Network Video Recorder

Version: V4.40.015 build 200616

Release Note

(2020-7-13)

4. 【Support Hik-Connect / GuardingVision to scan NVR QR code to recover password】

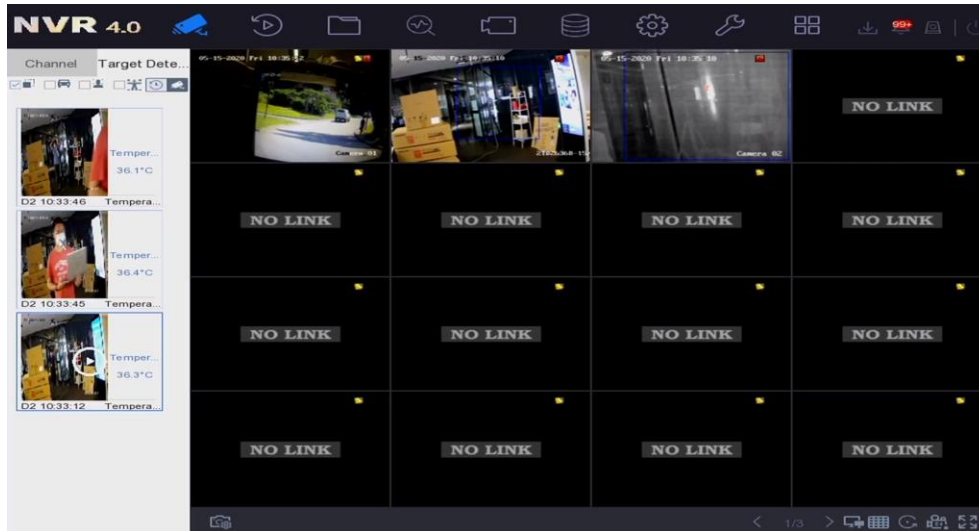
1) Support local HC / GV scanning QR code and mailbox to recover password, Local GUI delete the recovery way of GUID and security issues; WEB still retain GUID, security issues and mailbox to recover password.

2) Only the NVR that has been bound to the HC / GV will display the option to scan the code to recover the password.

3) Only the NVR-bound HC / GV client account can successfully recover the password.

4) Require HC/ GV v4.3.0 and later.

6. 【Support thermal camera temperature measurement alarm】

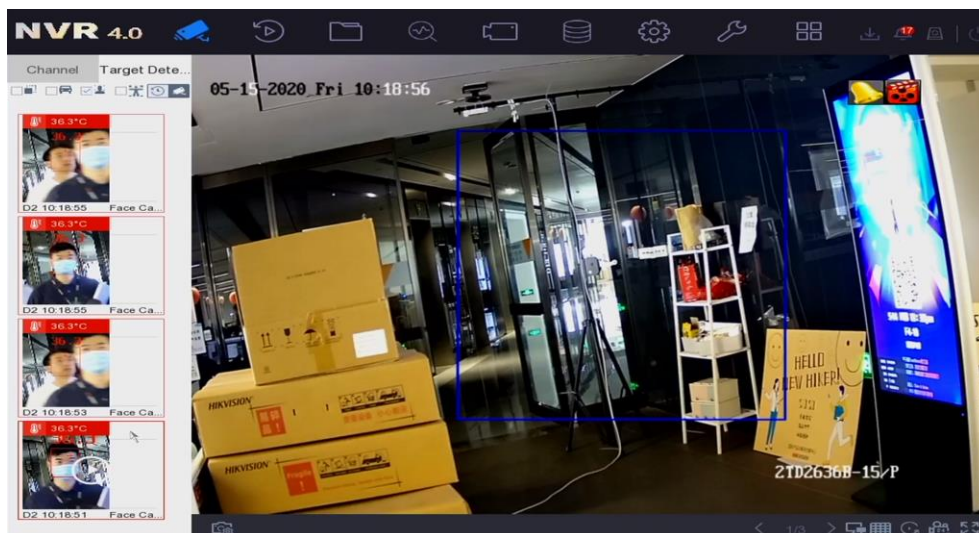
1) Support local target detection interface and 4200 to display real time temperature measurement alarm.

2) Support uploading pictures of visible light and thermal imaging to the platform software.

7. 【Support thermal camera face temperature alarm】

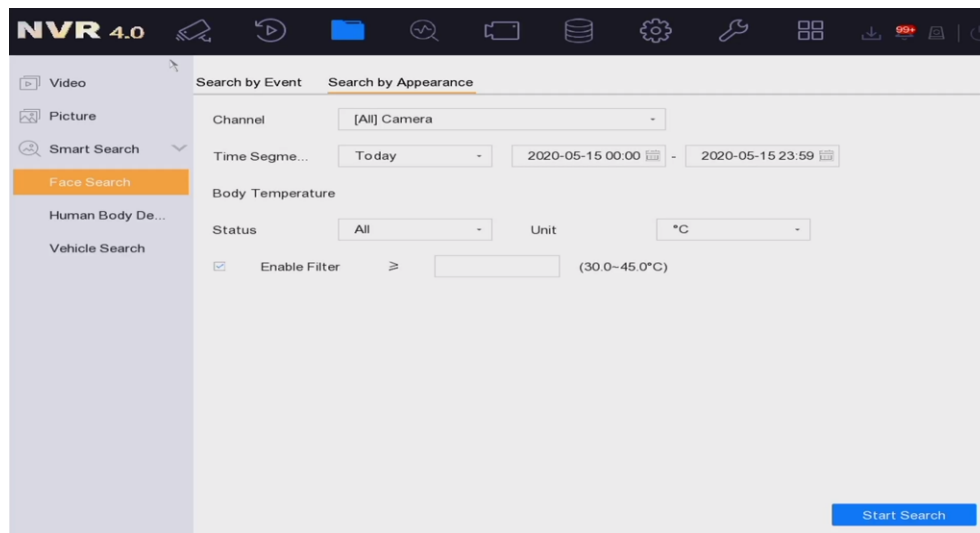
1) Support local target detection interface and 4200 to display real time face temperature alarm, abnormal temperature display red background, normal temperature display green background.

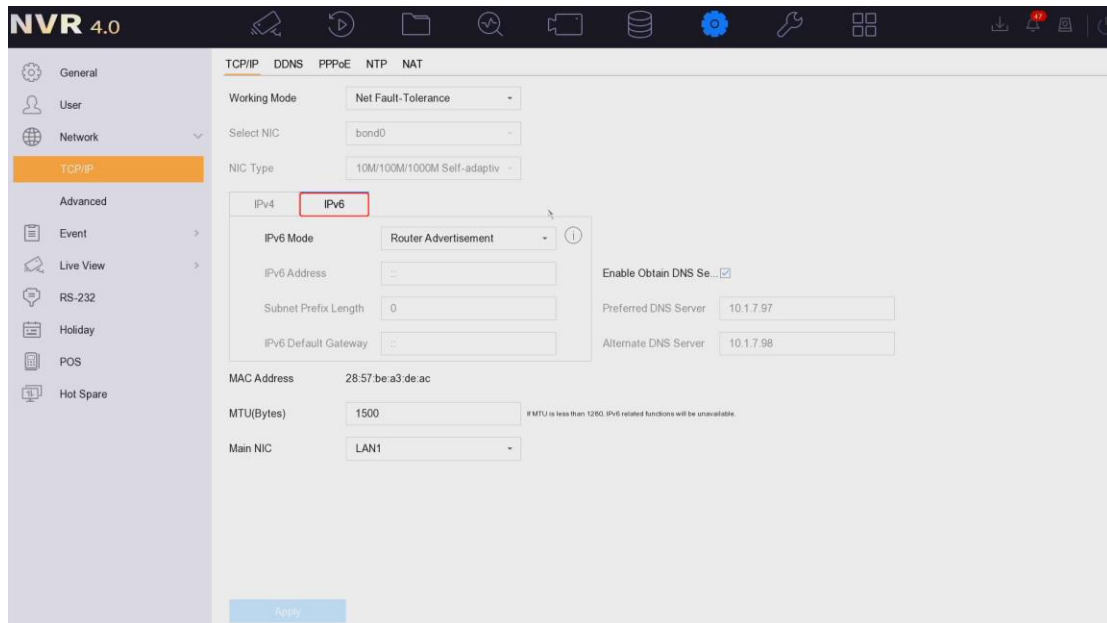
2) Support the voice announcement function of face temperature state linkage. NVR has two English pronunciations: abnormal temperature and normal temperature. Normal temperature is not linked by default, and abnormal temperature is linked by default.

3) Support local and 4200 to search face pictures according to body temperature status and temperature range, and support to display search results in specified temperature units.

8. 【Support IPv6 network】

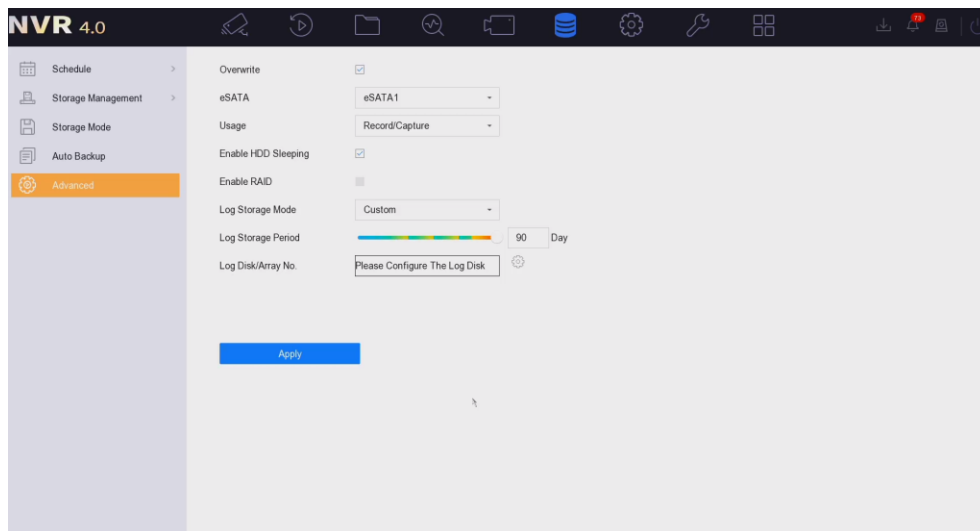
Support IPv6 network.
